Access Compliance Report

Public Rights-of-Way

(Curb Ramps)

Intersection ID: 30419	Main Street: FENWAY_DR	Cross Street: ELM_BEND_DR	Location: SW
ADA ID: A3040DFDFA33	Ramp Type: PerpDiag	Initial Pass/Fail: Fail	Overall Compliance: No
Severity Score: 21.25			
Codes/Mitigation Info/Possible Solution		Field Measurements/Component Compliance

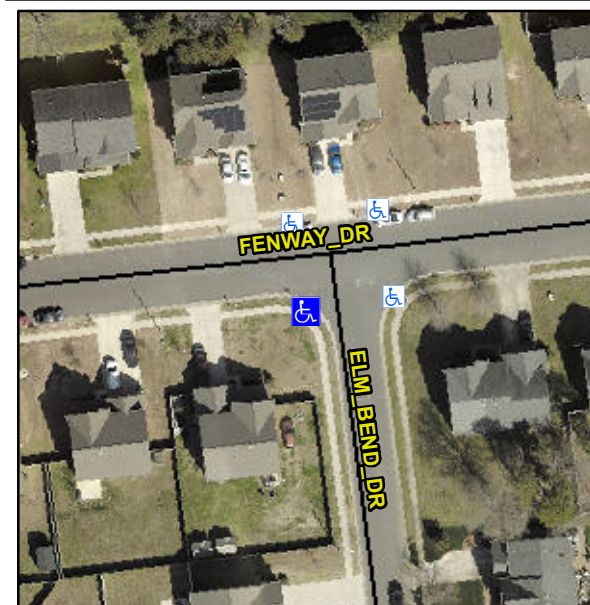
PROW/ADA:

Not Found, R304.5.1, R304.2.2

Compliance	Description	Data	Compliance	Description	Data
N/A	Ramp Length (in)	48.0	No	Ramp Slope (%)	9.2
No	Ramp Width (in)	47.0	Yes	Ramp XSlope (%)	0.7
N/A	Flare Type LT	N/A	N/A	Flare Type RT	N/A
N/A	Flare Slope LT (%)	N/A	N/A	Flare Slope RT (%)	N/A
N/A	Flare Traversable LT?	N/A	N/A	Flare Traversable RT?	N/A
N/A	Landing Length (in)	N/A	N/A	DWS Provided?	N/A
N/A	Landing Width (in)	N/A	N/A	DWS Contrast?	N/A
N/A	Landing Slope (%)	N/A	N/A	DWS Length (in)	N/A
N/A	Landing X Slope (%)	N/A	N/A	DWS Full Width?	N/A
N/A	Landing Curb? (Y/N)	N/A	N/A	DWS Offset (in)	N/A
N/A	Shared Landing?	N/A			
N/A	Gutter Ponding?	N/A	N/A	Gutter Slope (%)	N/A
N/A	Gutter Lip Ht (in)	N/A	N/A	Gutter X Slope (%)	N/A
N/A	Painted X Walk1?	No	N/A	Painted X Walk2?	No
	X Walk 1 Direction	To E		X Walk 2 Direction	To N
N/A	X Walk 1 Width (in)	N/A	N/A	X Walk 2 Width (in)	N/A
	X Walk 1 Slope (%)	1.9		X Walk 2 Slope (%)	1.2
	X Walk 1 X Slope (%)	0.5		X Walk 2 X Slope (%)	0.3

Remove & Replace Curb Ramp With Two New Directional Ramps or Equivalent.
